NEW YORK STATE
BOARD ON ELECTRIC GENERATION
SITING AND THE ENVIRONMENT

CASE 17-F-0282

**PETITION FOR REHEARING AND DECLARATORY RULING
AND MOTION FOR STAY**

Re: Case No. 17-F-0282 | All-Catt Wind Energy LLC
Response to Alle-Catt March 20, 2025 Letter

Figure 1. USGS chart of ACWE project area with DEM analysis overlay area shown with black ink outline. Turbine locations shown with WT 52 added March 2025.

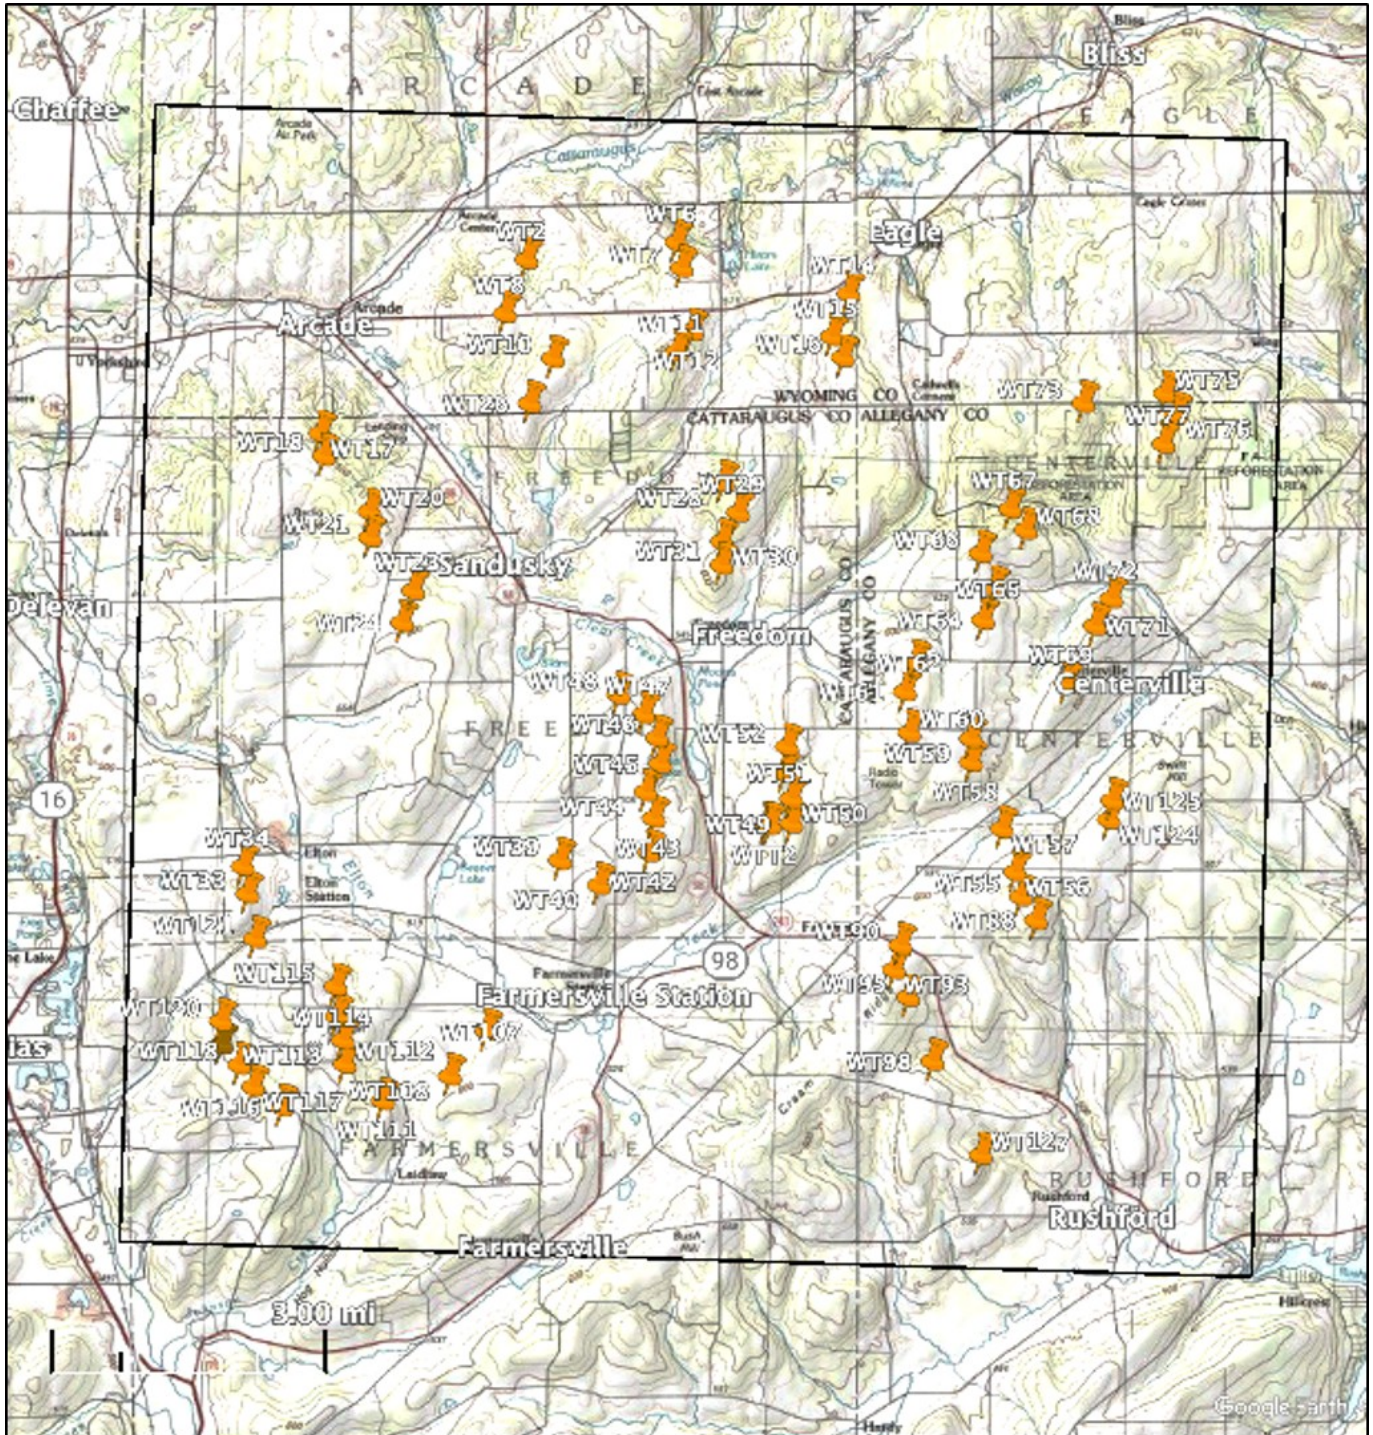
Figure 1 below shows the USGS topography for the ACWE project area. Significant elevation changes are clearly visible throughout the project area. Steep slopes are visible where topographic lines run closely together along hillsides.

Figure 2. Slope in ACWE project area. Green, yellow, orange and red show slopes exceeding 0, 5, 10, and 15 percent slope, respectively. Turbine locations shown with WT 52 added March 2025.

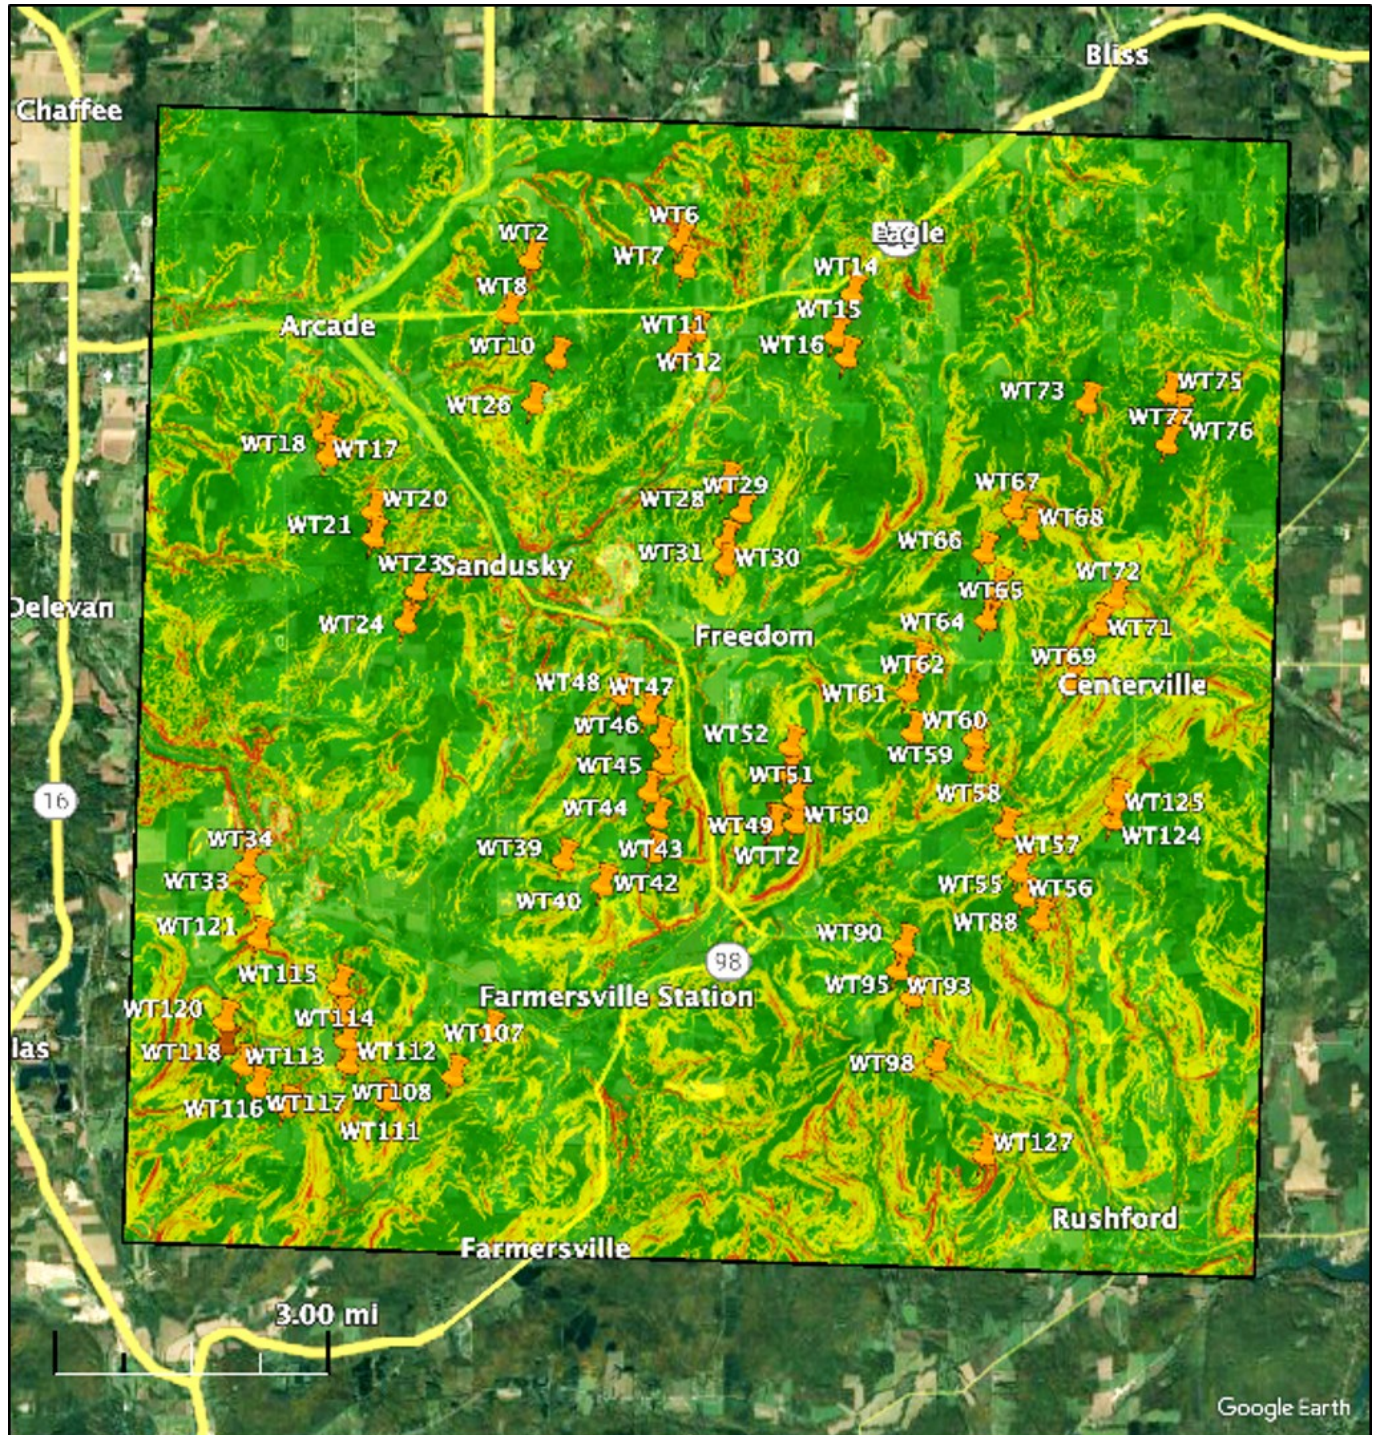
Figure 2 shows a raster image with computed slopes in degrees through the ACWE project area. Green, yellow, orange, and red raster shadings show slopes exceeding 0, 5, 10, and 15 percent slope, respectively. Significant terrain slopes are therefore clearly present throughout the project area.

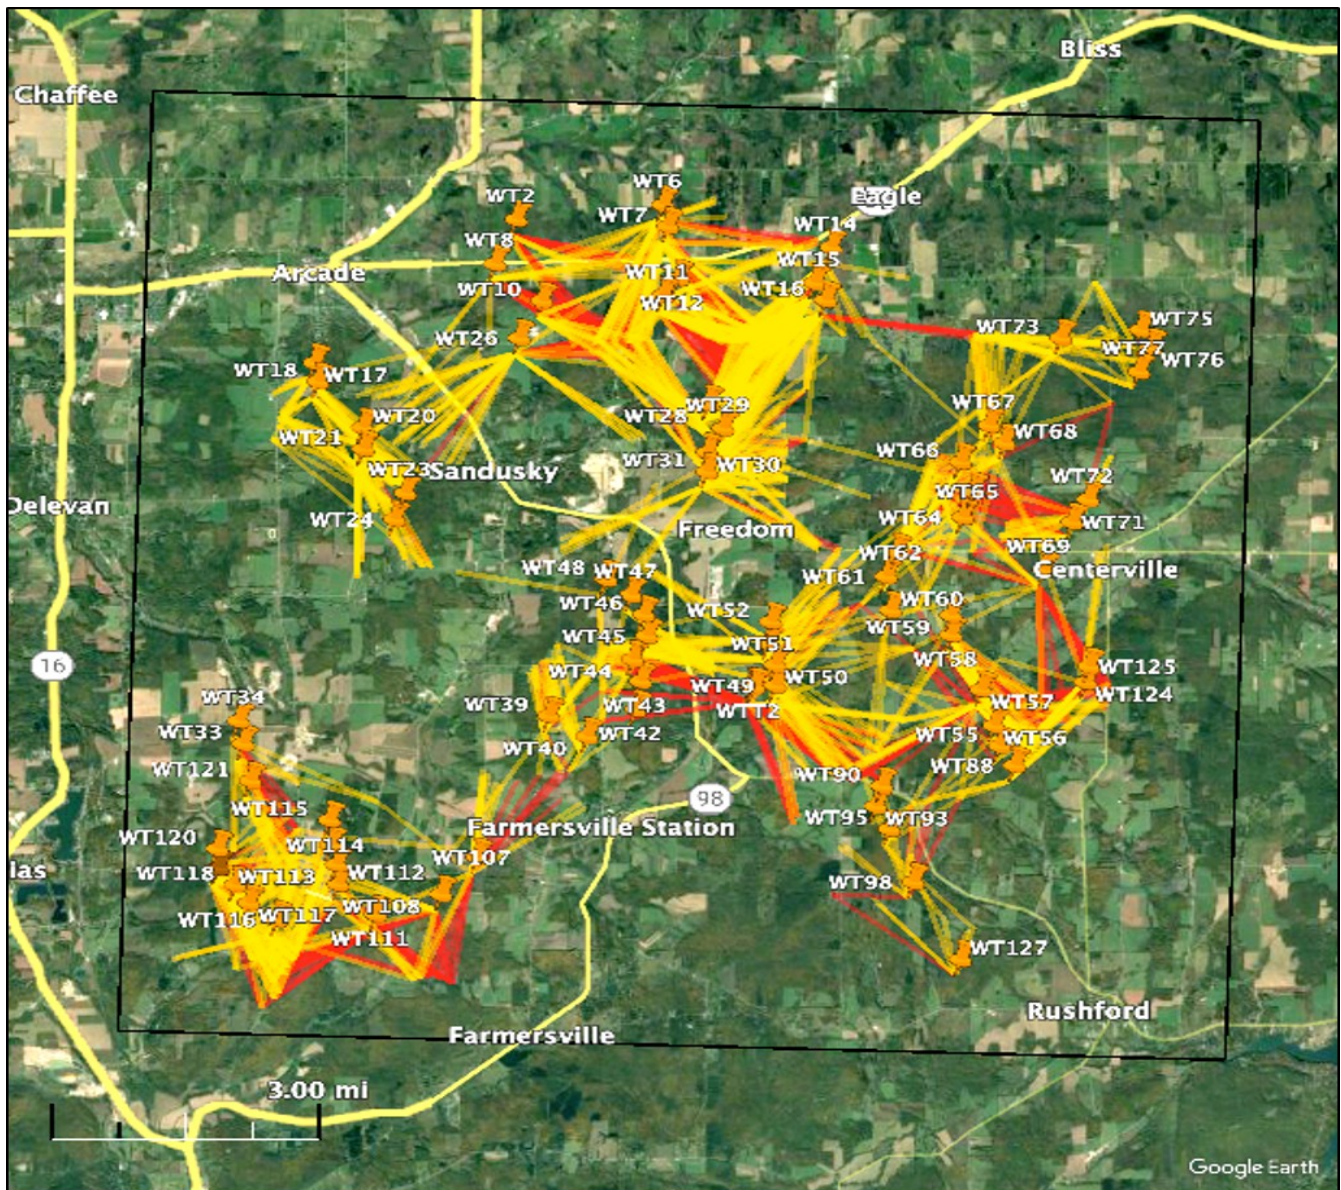
Figure 3 below shows computed slope ratios along line-of-sight acoustic paths between turbines and receptors. Slope ratios are the ratio between mean height between source and receptor and the mean height of the line-of-sight between source and receptor and the average terrain elevation along the path directly under the line-of-sight path. For example, *on level ground*, the mean height between turbine hub height and receptor is the same as the mean height of the line-of-sight between hub height and receptor; the ratio is 1.0. As the terrain drops away below the line-of-sight path, the ratio increases, indicating that terrain slope is concave.

Figure 4. Concave slope ratios by turbine for each receptor with line of sight within 3000 meters. Turbines shown with WT 52 added March 2025.

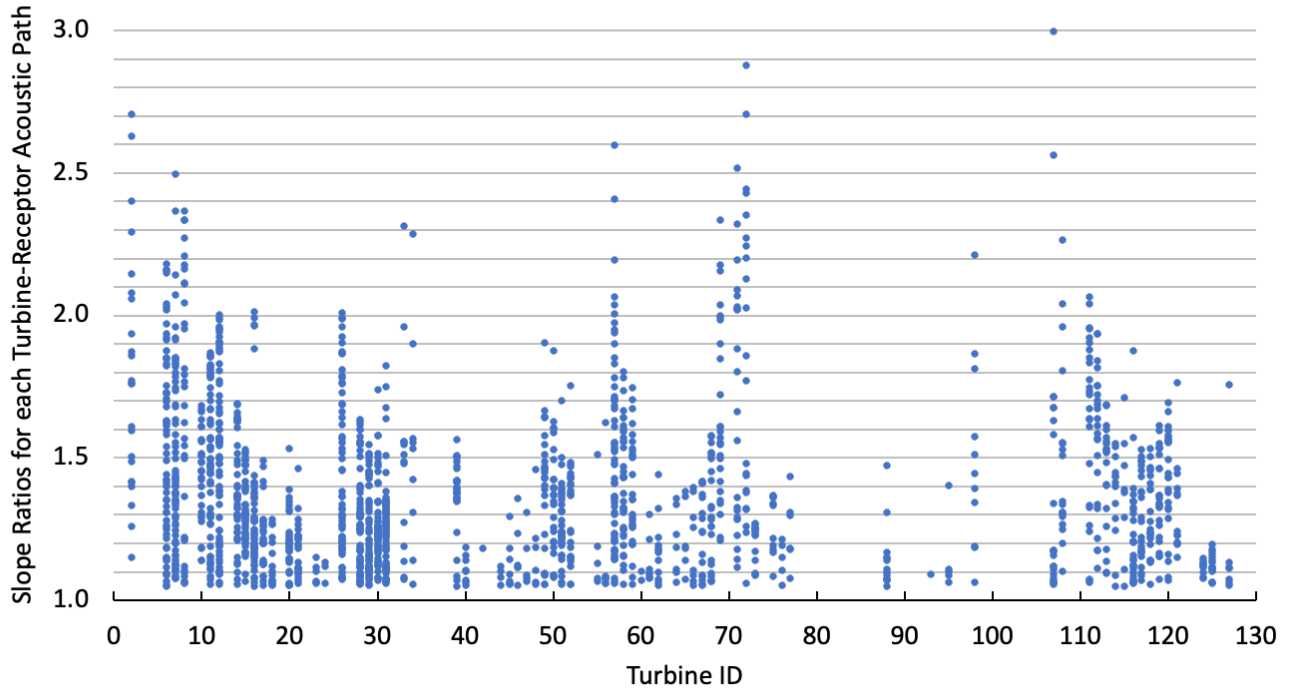
Figure 4 and 5 below show concave slope ratios between turbines and receptors summarized by turbine and by receptor, respectively. Numerous turbine-receptor paths have slope ratios over 1.5, consistent with a 3-dB uncertainty to be applied in the ISO 9613-2 model per Bass, Bullmore, and Sloth, 1998.

Figure 6. Concave slope ratios for all source-receptor acoustic paths within 3000 meters.

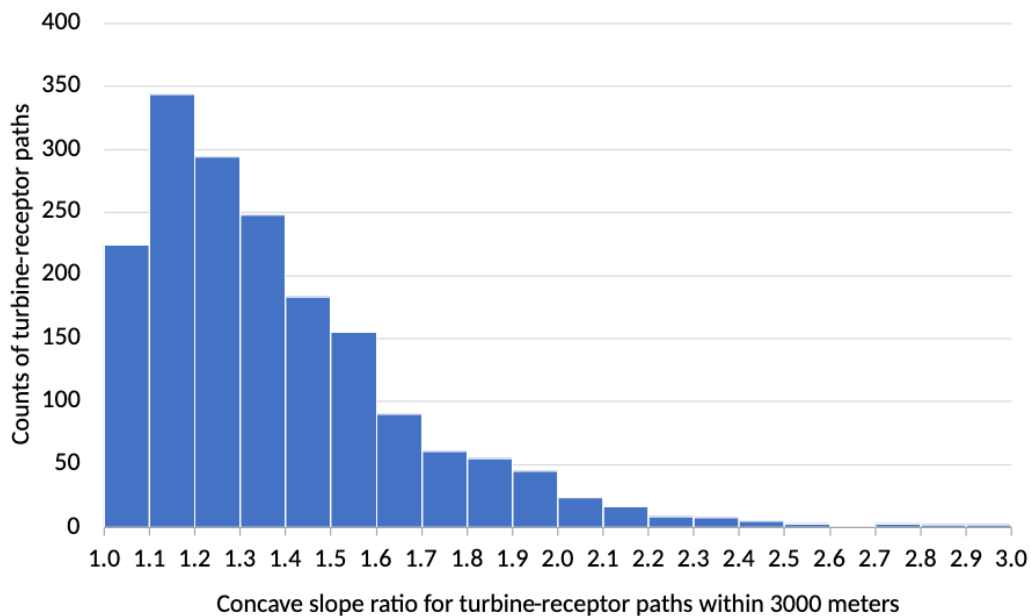
Figure 6 below shows a summary histogram of concave slope relations inside the ACWE project area. Several hundred source-receiver paths have concave slope ratios exceeding 1.5, consistent with a 3-dB terrain slope factor entered at the head of the ISO 9613-2 model, per Bass, Bullmore, and Sloth (1998).

The presence of hundreds of significant concave slopes in the project area unaddressed by the PNIA raises doubt as to whether Hankard's methods are sufficiently conservative to assure the Siting Board that non-participating residents will be protected from unwanted noise, and thus that complaints during operations will be rare.
